OICA and CLEPA joint position

ECE-TRANS-WP.29-GRE-2023-27e-Rev.1

OICA – CLEPA joint position

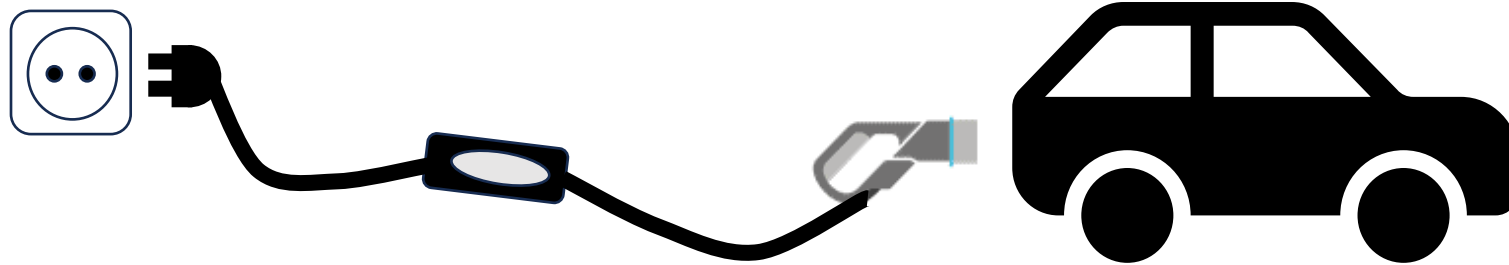
*¹ IEC 61851-21-2 tests shall be performed by an ISO17025 accredited laboratory **recognised by any Technical Service designated by the type approval Authority.** The test report shall be provided by the vehicle manufacturer as evidence for the vehicle type approval.*

- This note introduces dual qualification requirements for test laboratories, (text highlighted above)
- We request the highlighted text to be removed.

Recommendation: Remove “recognised by any Technical Service designated by the Type Approval Authority”.

IEC 61851-21-2 tests shall be performed by an accredited ISO/IEC 17025 laboratory ~~recognised by any Technical Service designated by the type approval Authority.~~ The test report shall be provided by the vehicle manufacturer as evidence for the vehicle type approval.

Dual qualification requirements:

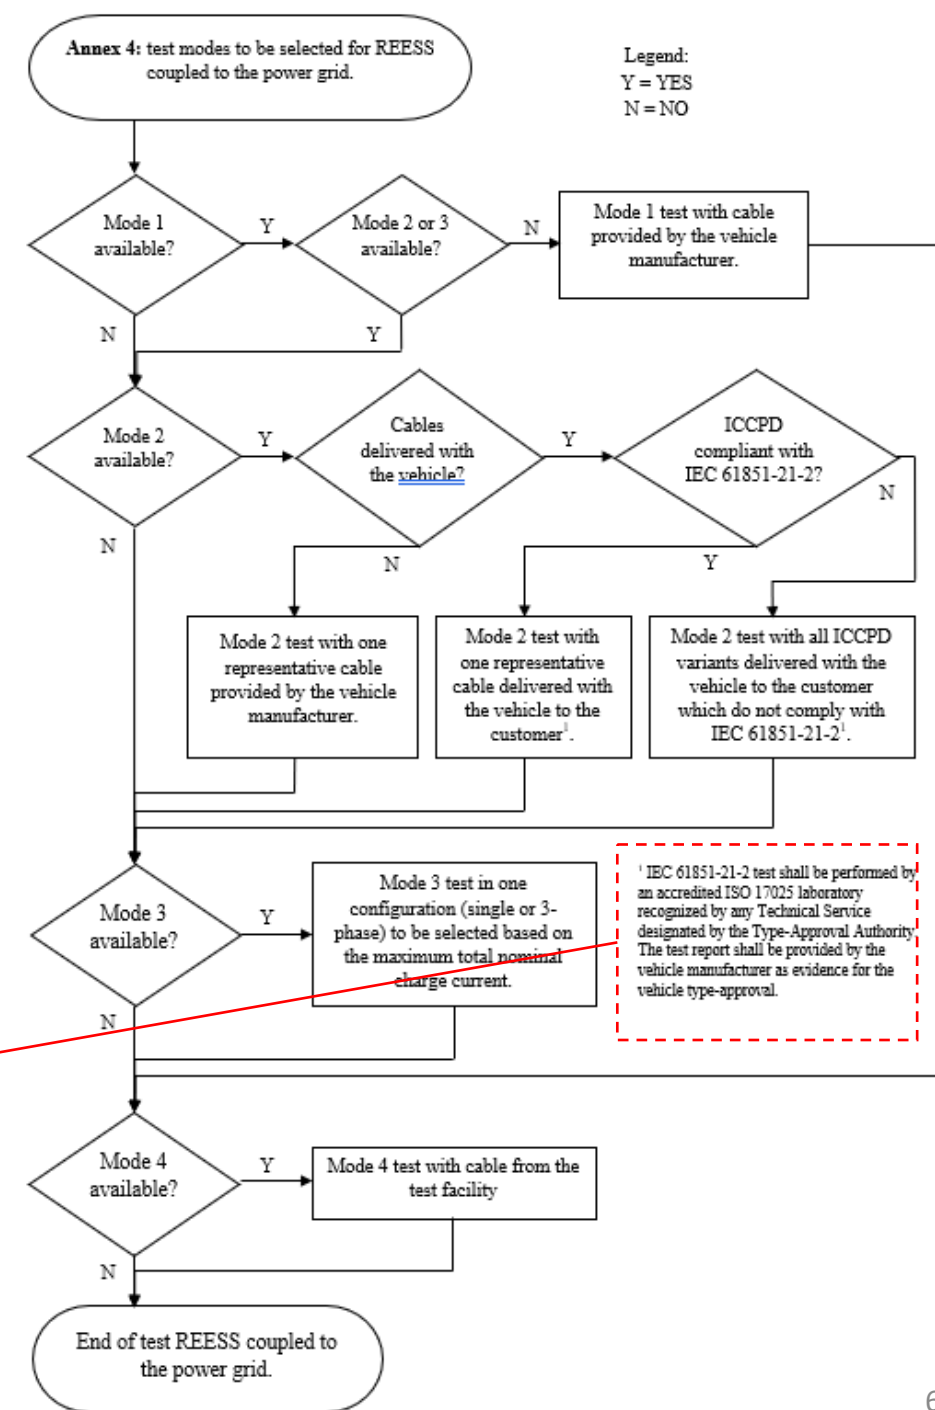
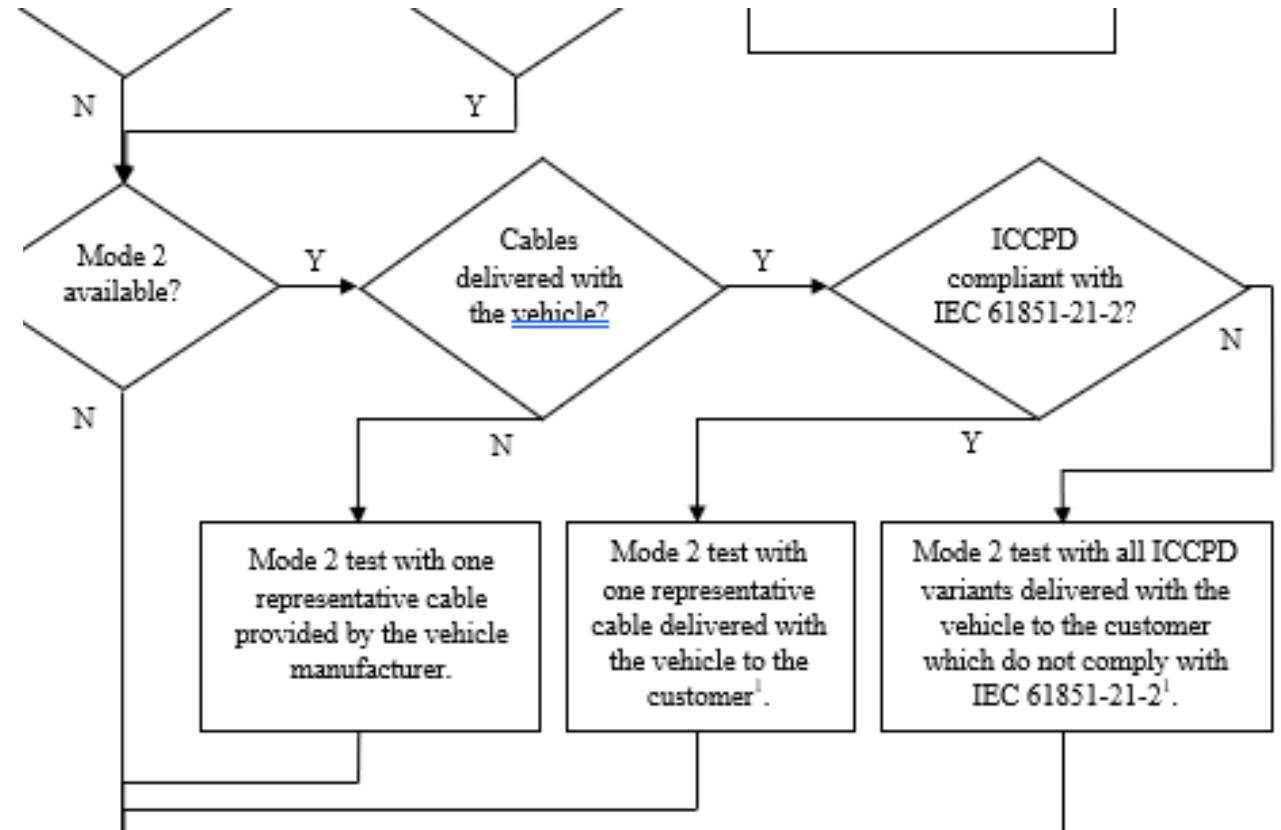
- Eligibility criteria requires dual qualifications to ISO 17025 **AND** to be recognised by any Technical Service designated by the type approval Authority

- Economic disadvantage to some countries:
 - Some (~ 8 countries) that have signed the 1958 agreement lack both a technical service and a lab recognised by a technical service.

- Restriction of competition:
 - In Germany for example, there are 336 test laboratories accredited to ISO/IEC 17025, but only 72 labs are recognized by a Technical Service. This will restrict the number of available laboratories and reduce competition.

- Lack of clear benefits
 - The effort for testing Mode 2 cables is not justified: There is neither a technical benefit nor a benefit related to better compliant results. Instead, it restricts free competition among labs and puts countries without any qualifying labs at an economic disadvantage.

- Use of laboratories accredited to ISO/IEC 17025 is sufficient and addition of the requirement of recognition by the technical service will not improve compliance results but instead will restrict competition and disadvantage some signatories to the 1958 agreement.
